Re: NEWBURYPORT - Solid Wastes/COR
Crow Lane
Crow Lane Landfill
Revised Closure Plan
Notice of Deficiency
File No. W046210
FMF No. 39545

Preliminary Shaw Review Comments relative to the SITEC Engineering Drawings Perimeter Berm and the MSE Wall

Shaw review of GeoComp's "REPORT ON ADDITIONAL GEOTECHNICAL ANALYSIS"

Drawing 5 – Westerly Perimeter Berm detail:

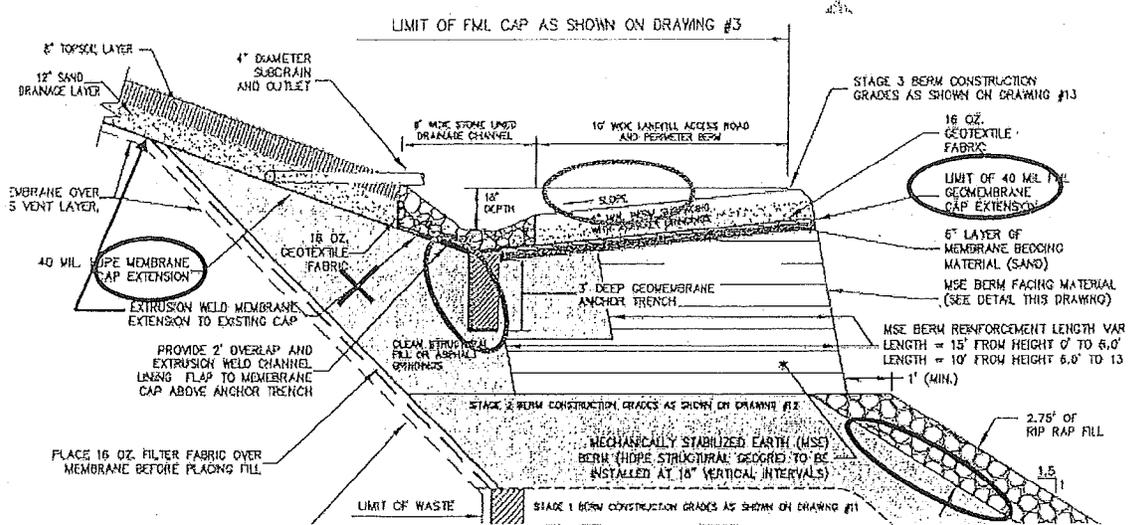
1. The callouts identifying extrusion welds between membrane appear are confusing. Should the call out "Extrusion weld membrane extension to existing cap be at the top of the existing cap steep slope? It appears that the

Geomembrane cap extension is continuous under the swale, so the purpose of the anchor trench is not clear, and how the weld to it would occur. If an additional swale liner is desired, then it could be just layered on top of the cap extension: (Unless the lines are miss-labeled and then these should be corrected).

2. What is the slope of the road to the channel, or the height of the channel adjacent to the road?
3. What will prevent the existing berm material under the riprap from eroding? Either a geotextile or graded stone is needed between the riprap and the existing berm.

Drawing 6 – Detail Southern Perimeter Berm Detail Structural Fill.

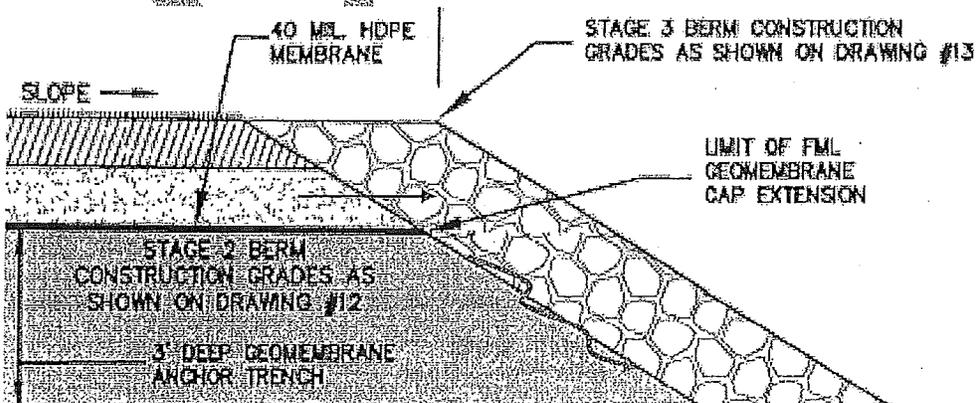
1. What will prevent the drainage layer sand above the 40 mil HDPE membrane from washing out at the FML limit into the riprap?
2. What will prevent the existing berm material under the riprap from eroding? Either a geotextile or graded stone is needed between the riprap and the existing berm.

Figure 7-27 Angle Of Repose Of Riprap In Terms Of Mean Size And Shape Of Stone (metric units)

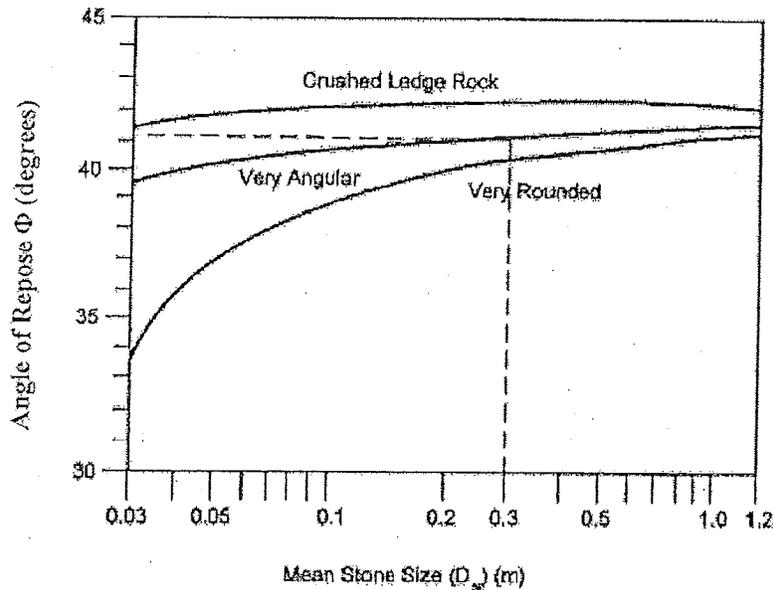
As noted in the figures below from the Connecticut DOT Drainage Manual, the maximum angle of repose for stone sizes similar to the sizes proposed for the buttresses is less than 43 degrees.

Figure 3.24. Stone weight versus stone size for riprap.

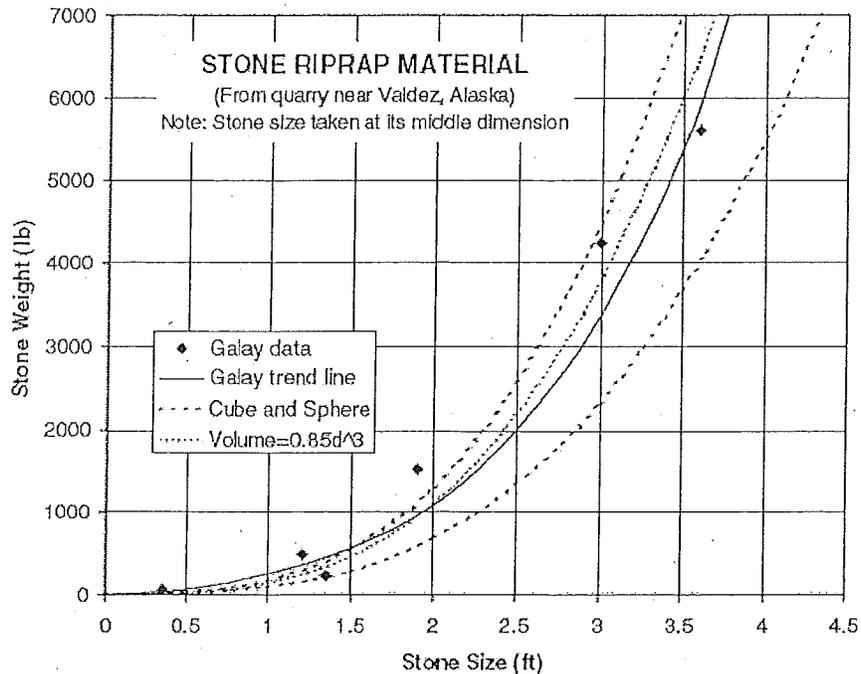
In addition, unless the rock placement is such that there is less than 20% voids, the required buttress's overall density used in the stability analysis cannot be achieved. As demonstrated in Figure 3.24 from the National Cooperative Highway Research Program (NCHRP) Report 568, the size and shape of the rock significantly affect the bulk density of the embankment. For instance, due to voids, a fill with 3.15 ft cubic rocks neatly stacked will have a bulk density of 160 lbs/cf but a fill with 3.15 ft round rocks will have a bulk density of approximately 80 lbs/cf. So achieving the necessary 130 lbs/cf bulk density used in the stability calculations is not assured based upon the design presented so far.

In the construction specification for rip rap, allowable range of sizes and/or weights of the individual particles, allowable range of particle shape, minimum allowable density (or Gs), and the minimum allowable durability requirements should be addressed.
